FILE INQUIRY FORM

Property Address: 1985 SANDHILL Road

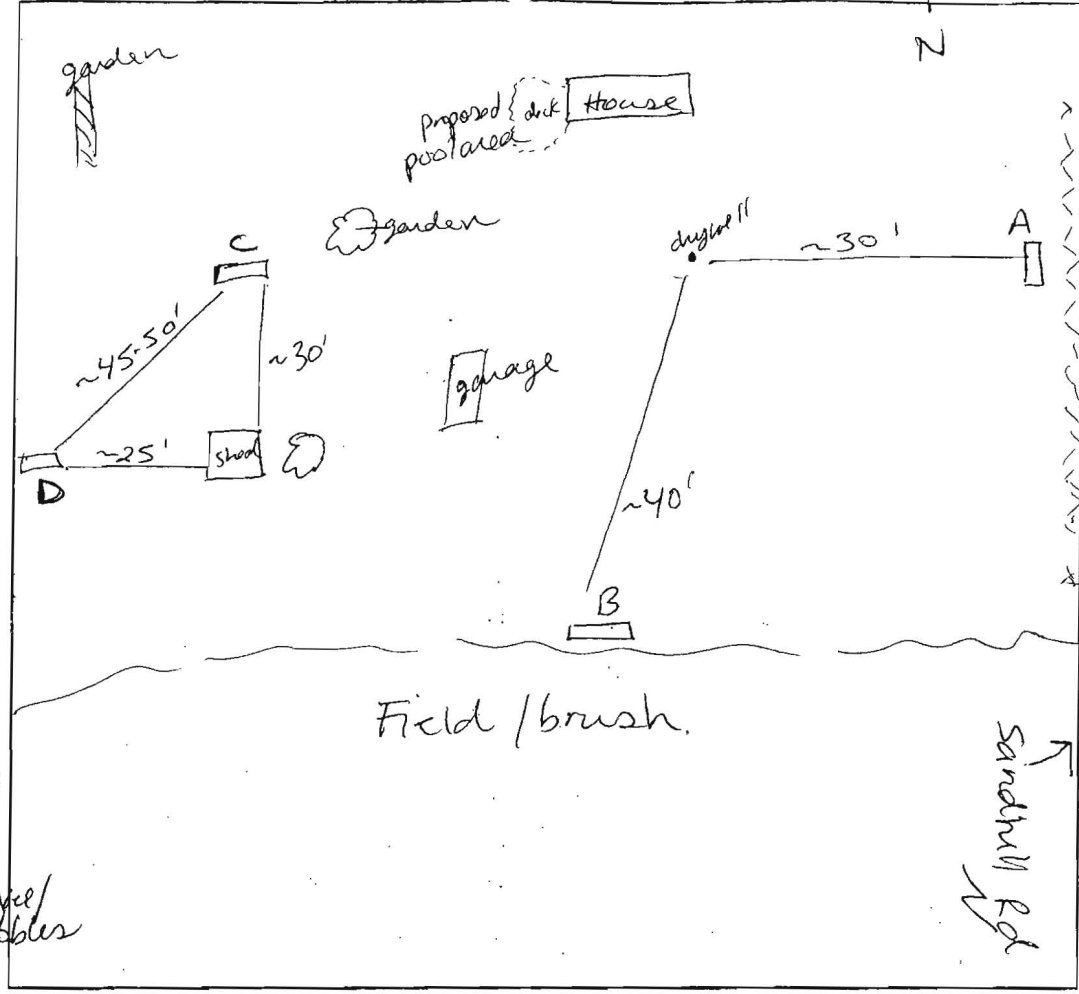
DATE	TEST #	DEPTH	START	BREAK 1" DROP	STOP 2" DROP	TIME OF 2nd INCH	P/F/H
10/20/05	A	6'9" / 14'	9:31 ⁰⁵	too clay clay/rock			F
	B	14'		deep clay water @ 9'5"-10'			VF
	C	3'5" / 13'	10:34 ⁰¹	10:36 ⁴⁵	10:40 ²¹	4	P
	D	3' / 12'	10:43 ¹⁴	10:51 ⁰⁵	11:05	14	P

REMARKS: Repair area established in high ground, open area on E side of property

10/20/05 Repair area established on property (SF)

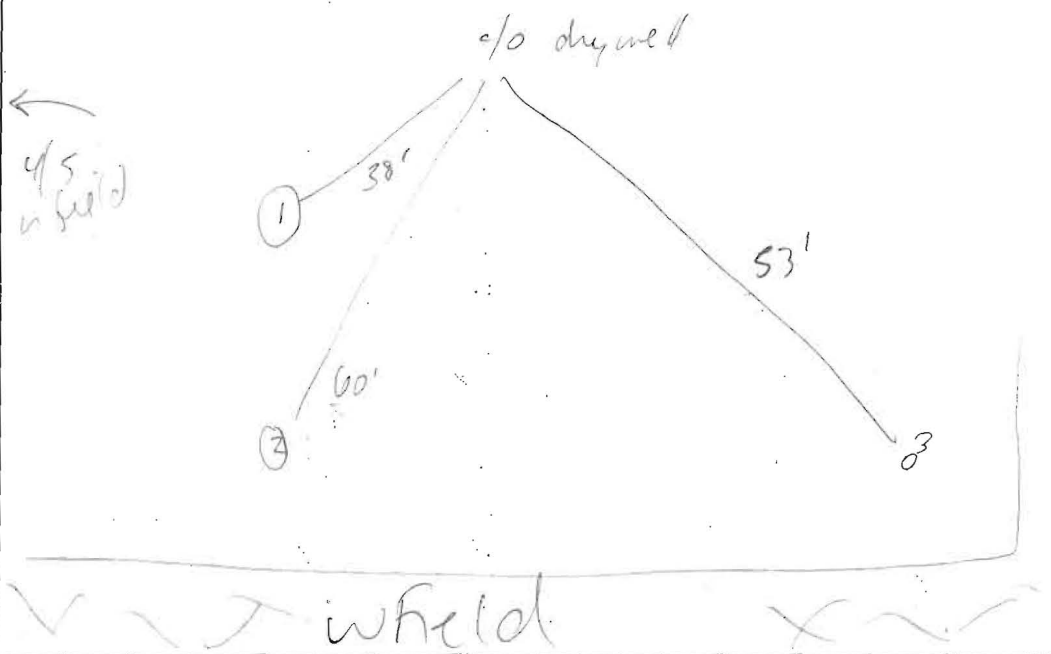
8/4/05* NEED SITE INSP - NO RECORDS

1) Auger soils - if too difficult may need a perc test done

2) See if effluent/sludge level
in S. TANK

Auger not successful. Perc test will need
to be done unless owners can find final plat showing
10,000 from planning and zoning. Effluent levels
also were looked at and were satisfactory. (SF)

8/16/05 Talked to owner about needing perc test.
will be in contact. (SF)
